Apex Waste Solutions Final Drainage Report

El Paso County, Colorado

PCD No. PPR2441

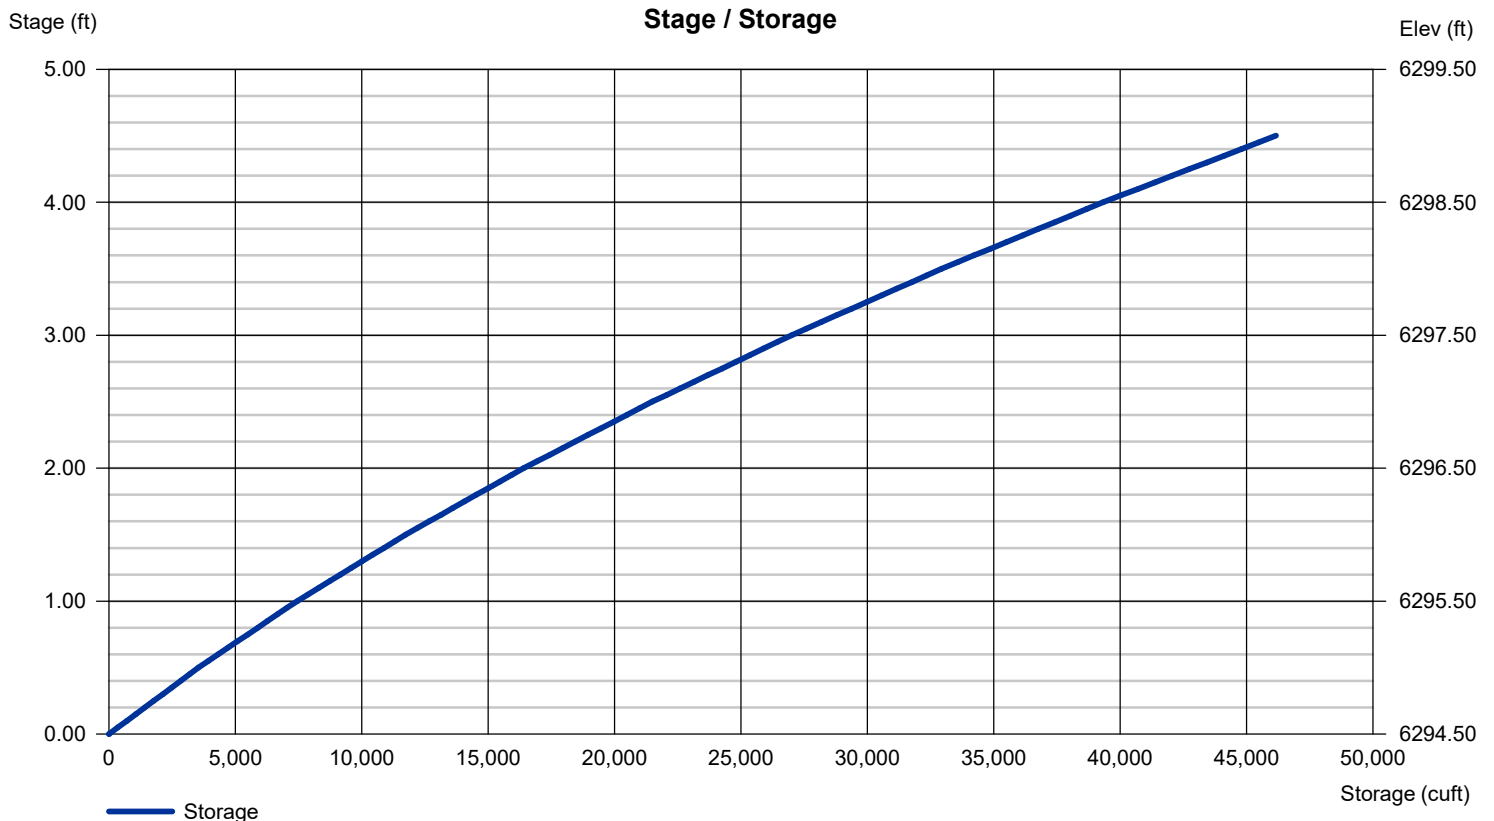
Is this the exfiltration Q as calculated to the side? Please make sure the names match. If not please identify what the discharge represents/what storm event.

Stormwater Detention and Infiltration Design Data Sheet

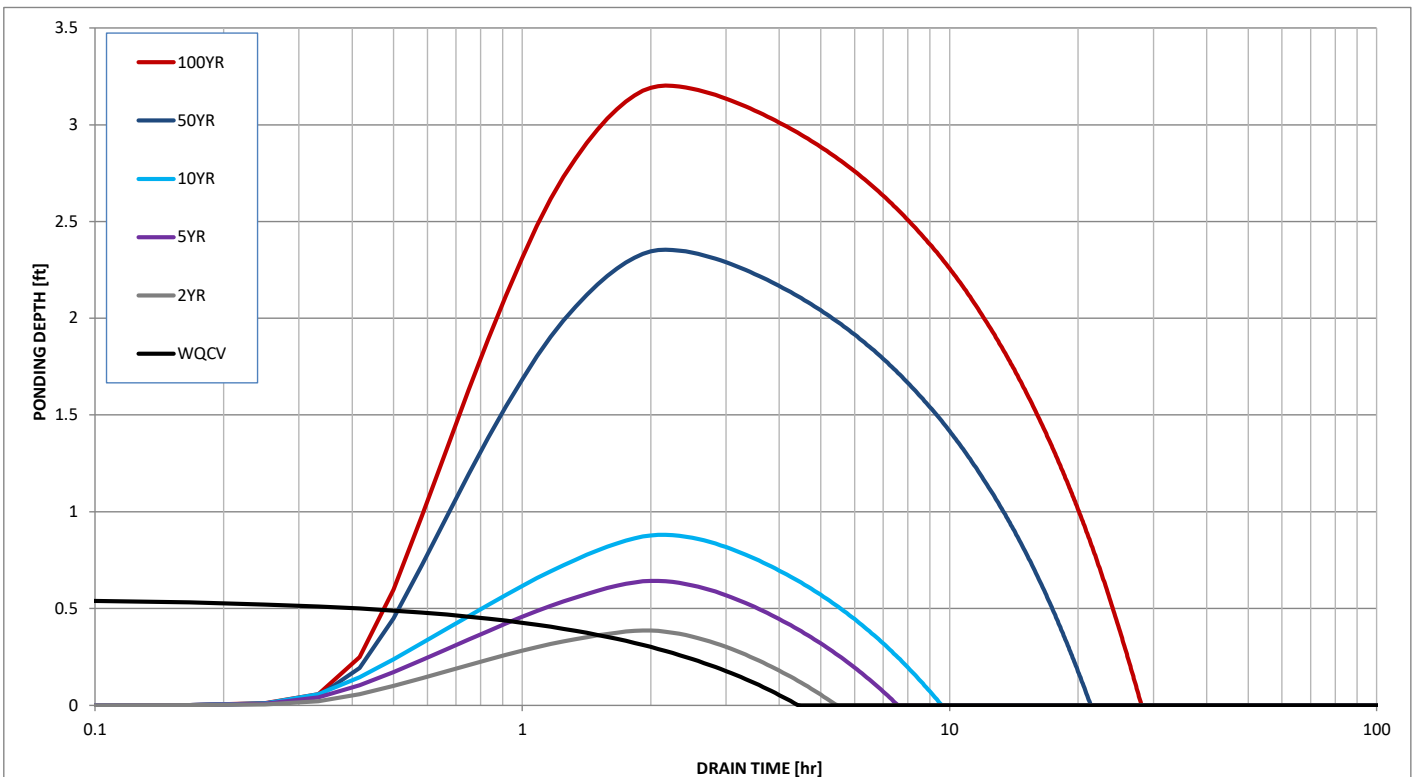
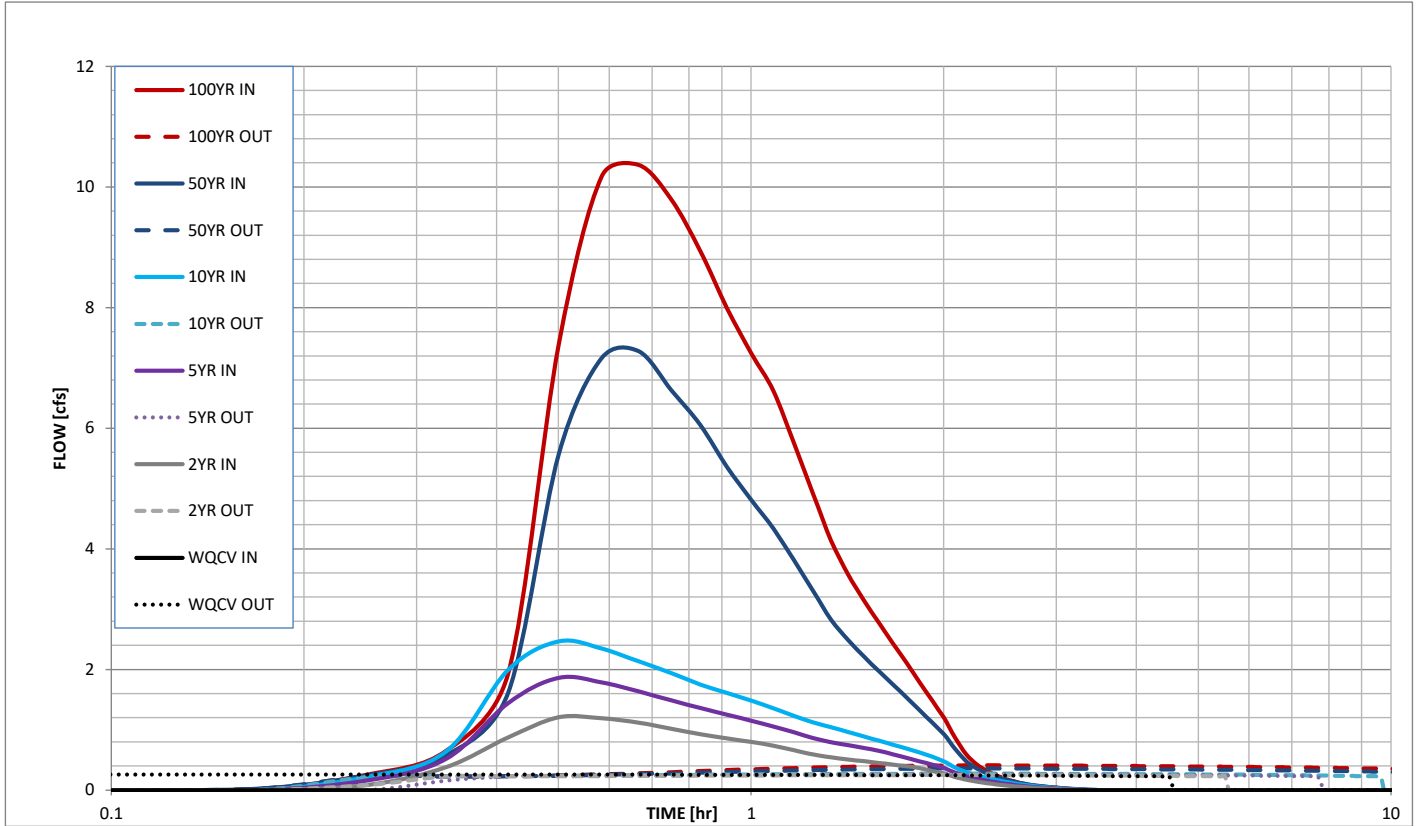
Provide calculations of drain times for design storm events. WQCV, EURV, 5-year, 100-year.

Because these volumes and surface areas aren't use - show calculated volumes/surface area based on the 100-year and clearly show drain times based on the actual designed dimensions.

DRAINAGE MAPS

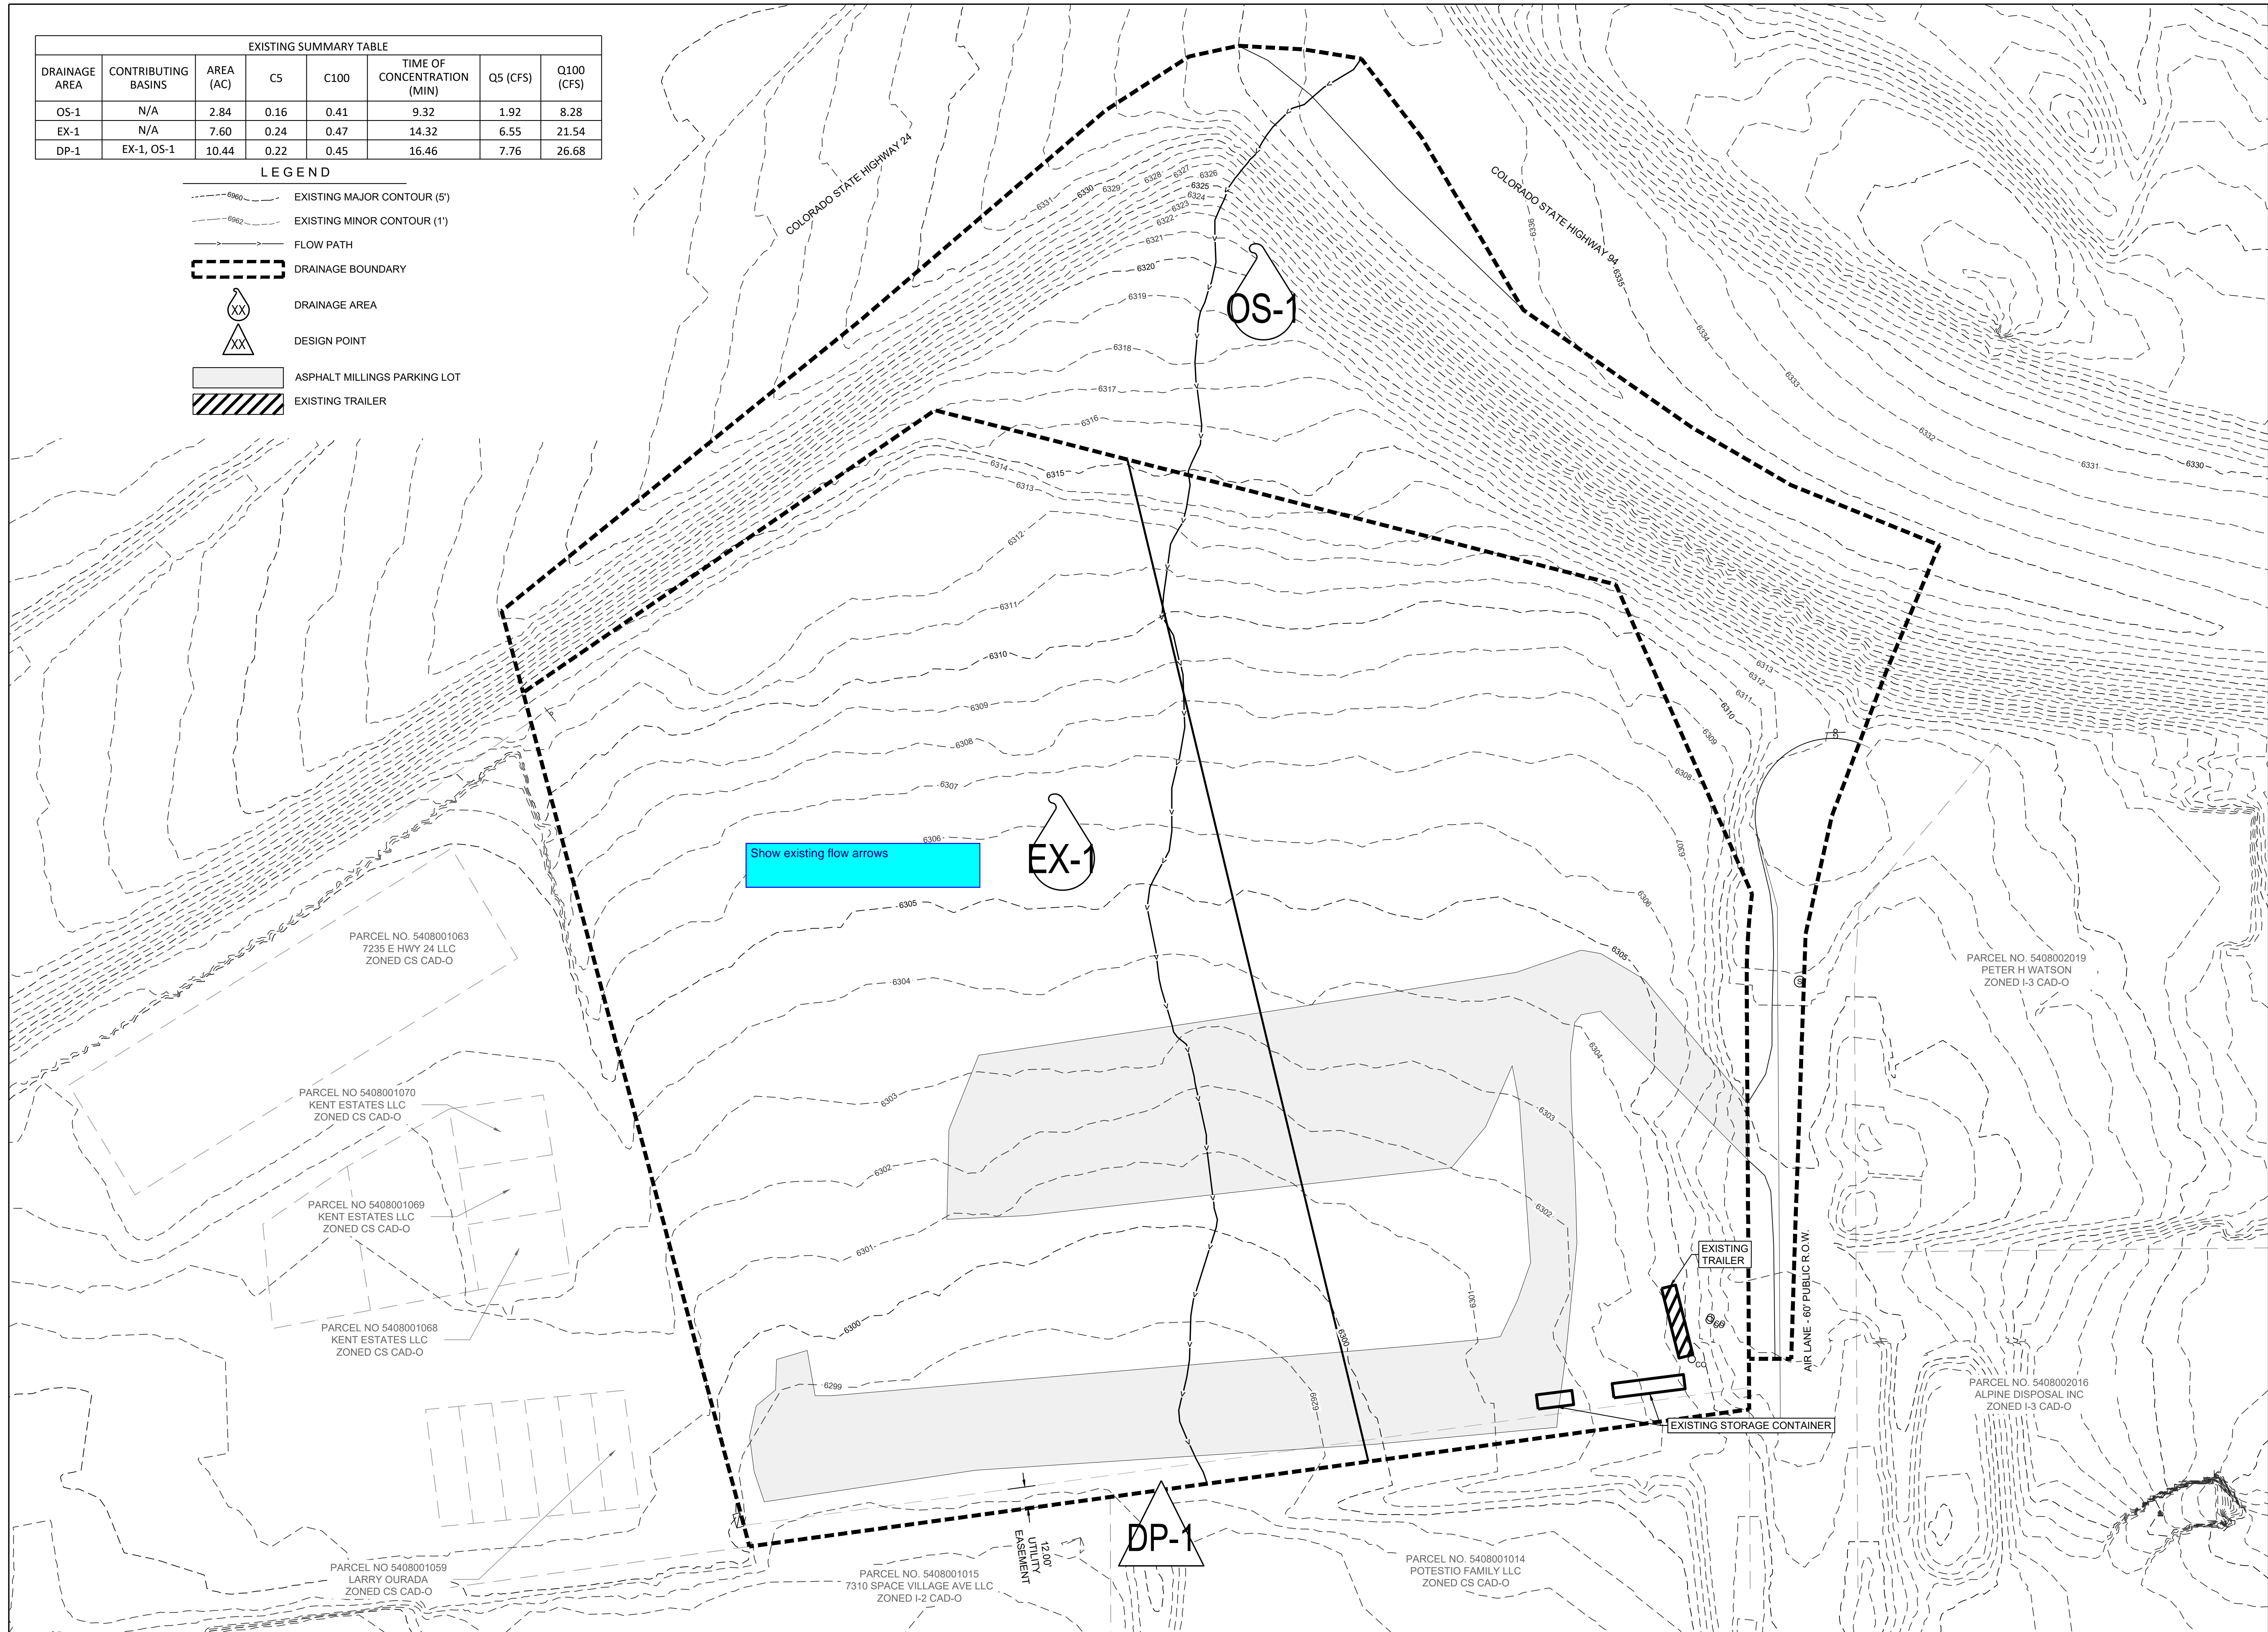
Show existing flow arrows

Show existing flow arrows

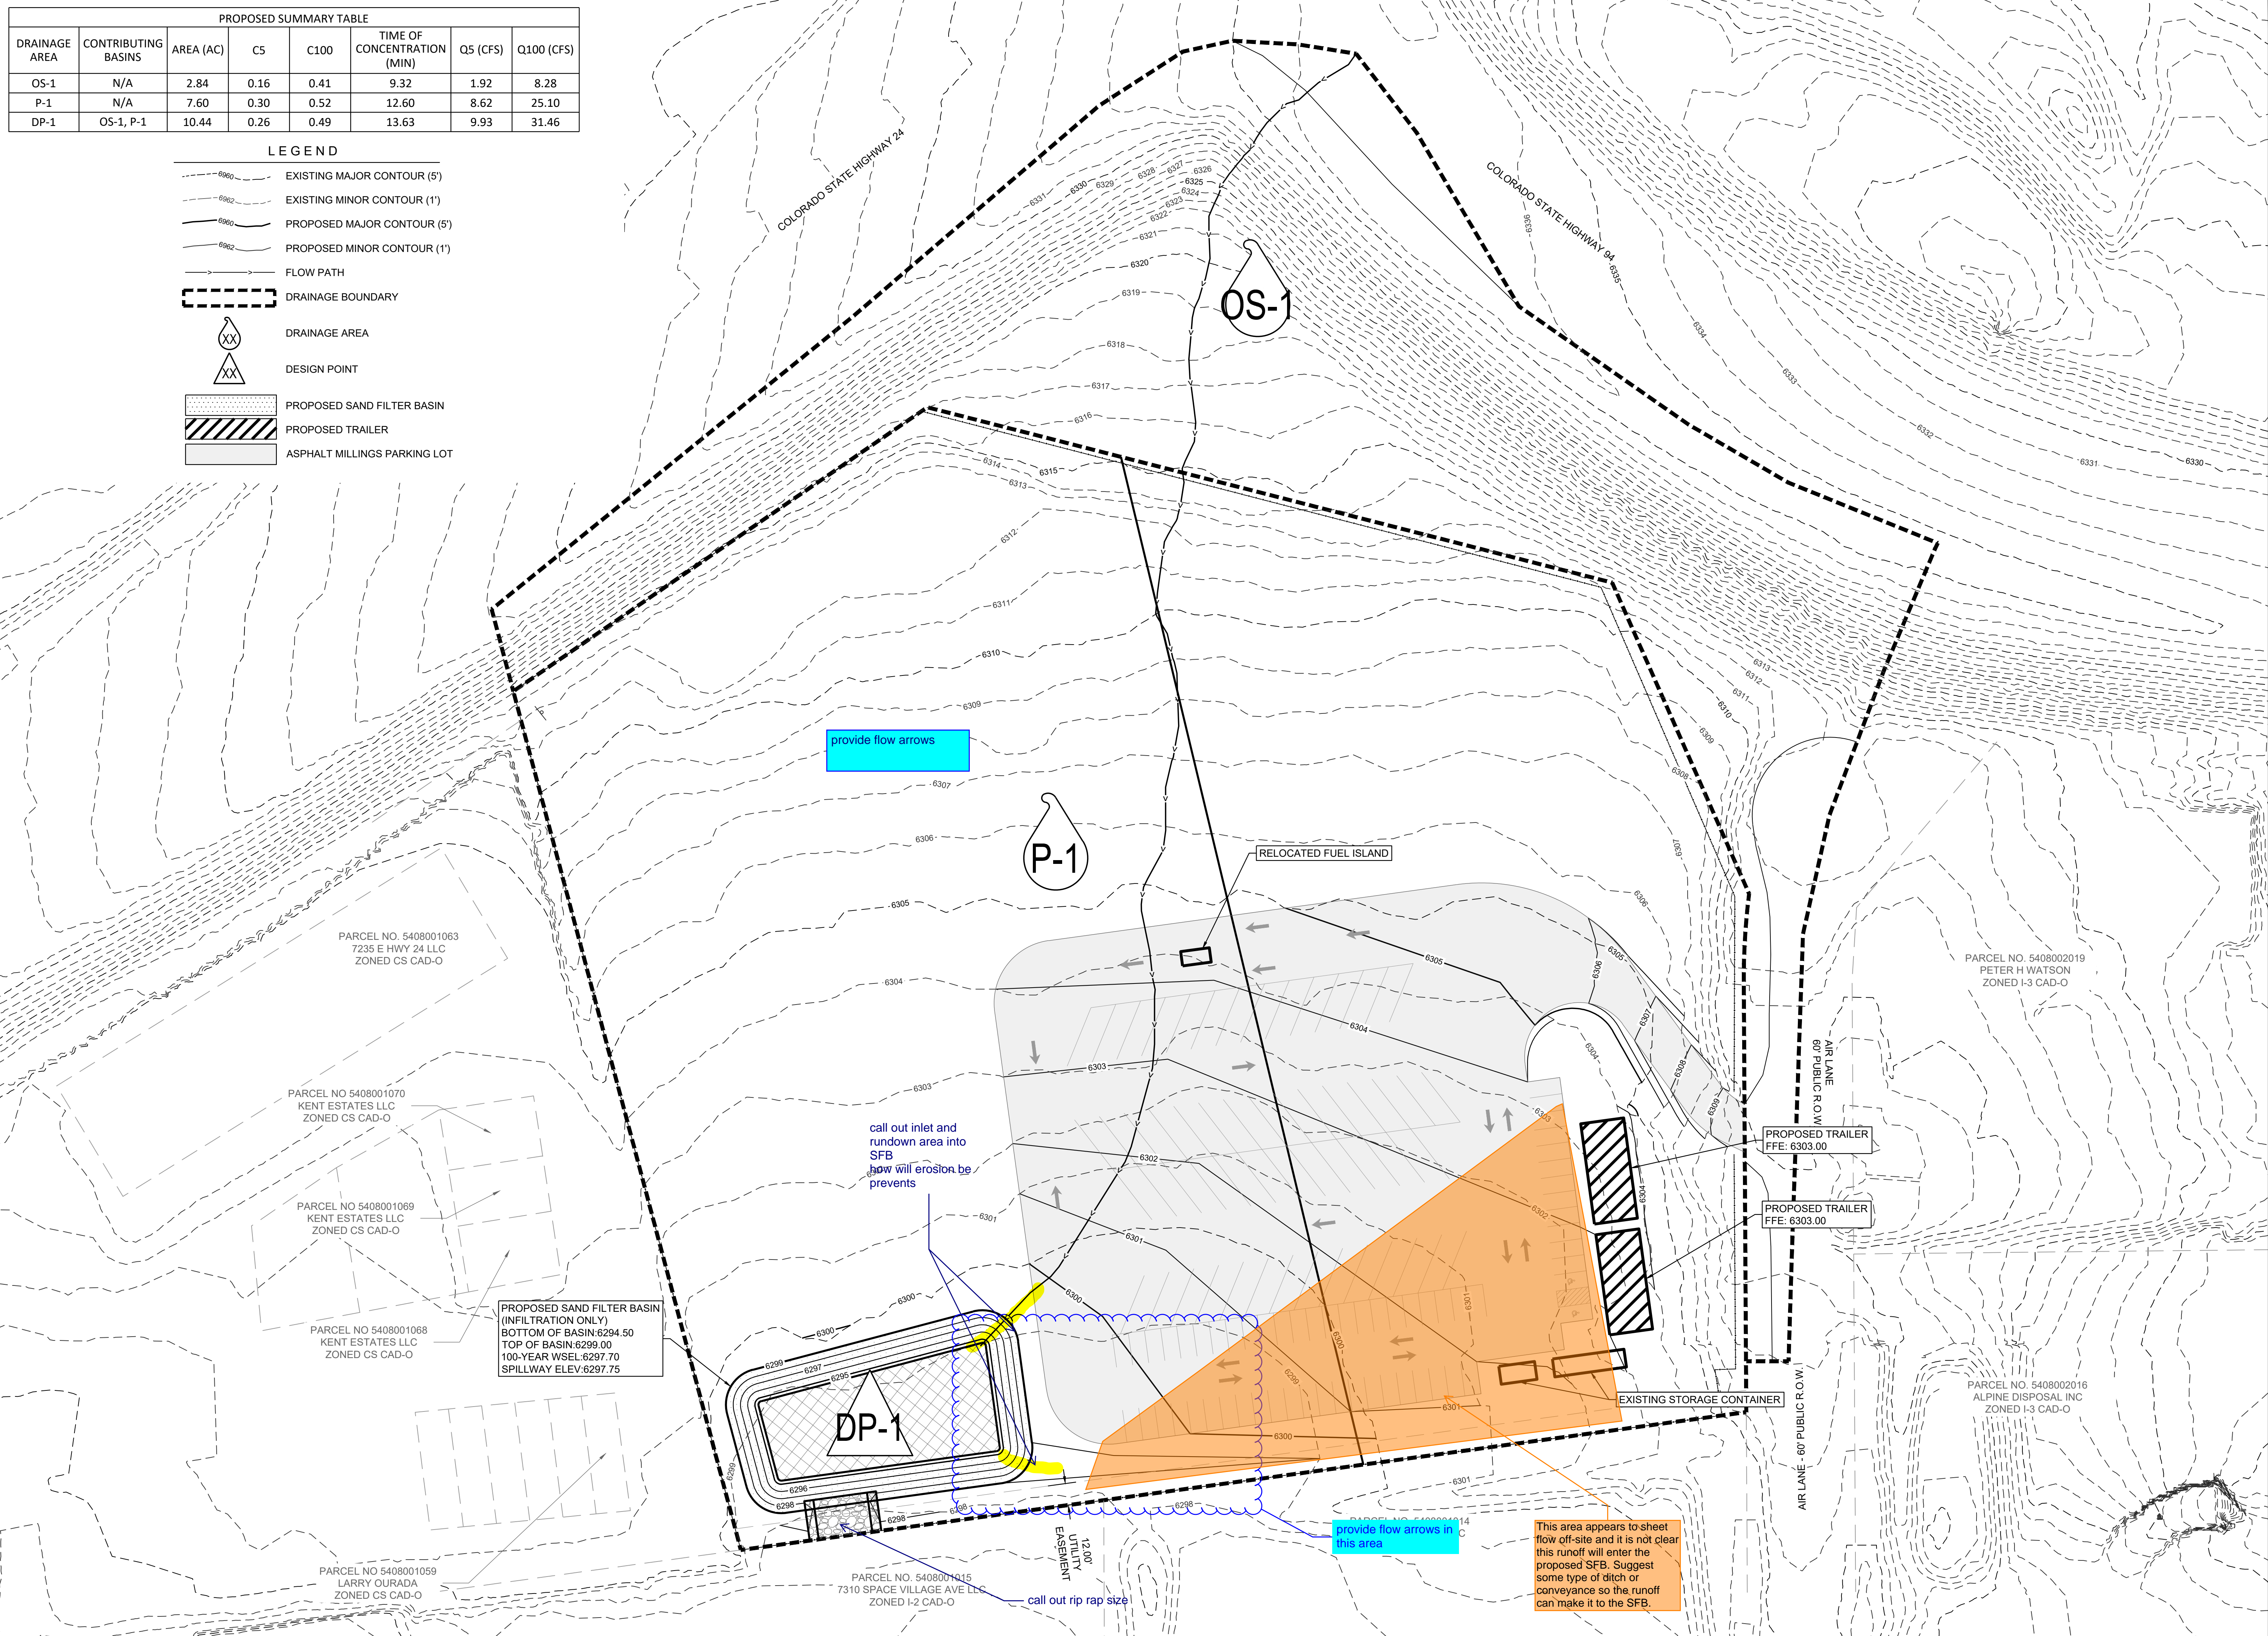
provide flow arrows in this area

provide flow arrows in this area

provide flow arrows

provide flow arrows

provide flow arrows

provide flow arrows

This area appears to sheet flow off-site and it is not clear this runoff will enter the proposed SFB. Suggest some type of ditch or conveyance so the runoff can make it to the SFB.
